# Comhairle Chontae Atha Cliath Theas

## Record of Executive Business and Chief Executive's Order

**Reg. Reference:** SDZ22A/0012      **Application Date:** 09-Aug-2022  
**Submission Type:** New Application      **Registration Date:** 09-Aug-2022

**Location:** 1, Adamstown Boulevard, Adamstown, Lucan, Co. Dublin

### **Road Alterations:**

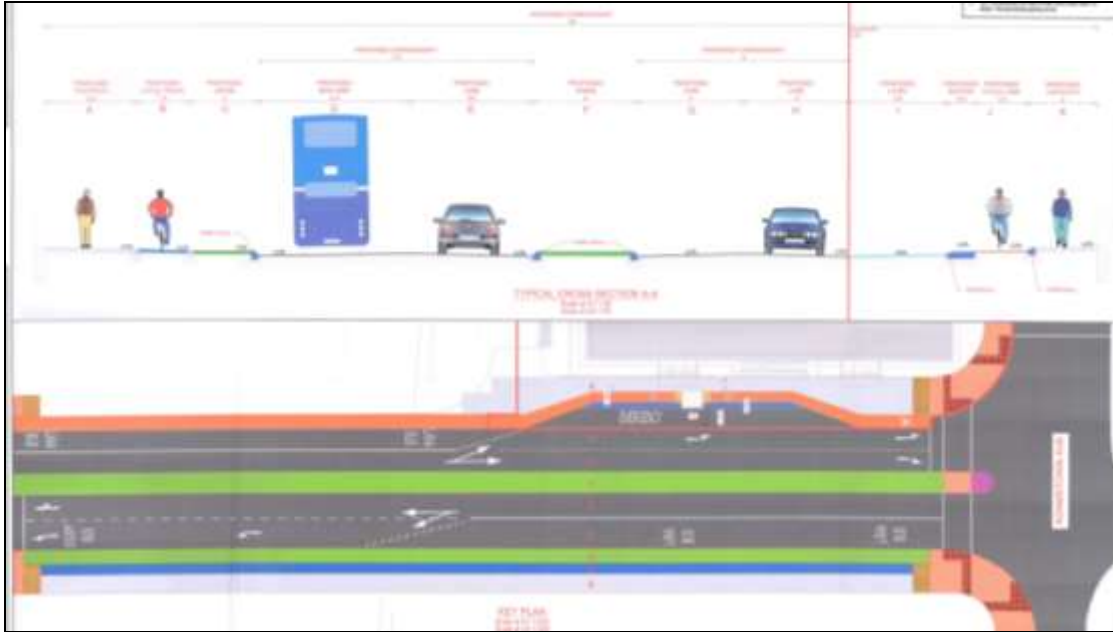
*The applicant has proposed the re-alignment of the cycle lane outside the main building entrance in order to accommodate an ambulance layby. This will involve the removal of several street trees and the reduction in width of the cycle path to 1.5m. The footpath will remain 2m wide.*

- (e) A Road Safety Audit which specifically examines the proposed ambulance lay-by and associated cycle lane re-alignment.
- (f) A revised layout of not less than 1:200 scale showing the location and number of bicycle parking spaces to be provided at the development. Please refer to Table 12.23: Minimum Bicycle Parking Rates – from the SDCC County Development Plan 2022-2028. All on-surface parking spaces shall be covered/sheltered.
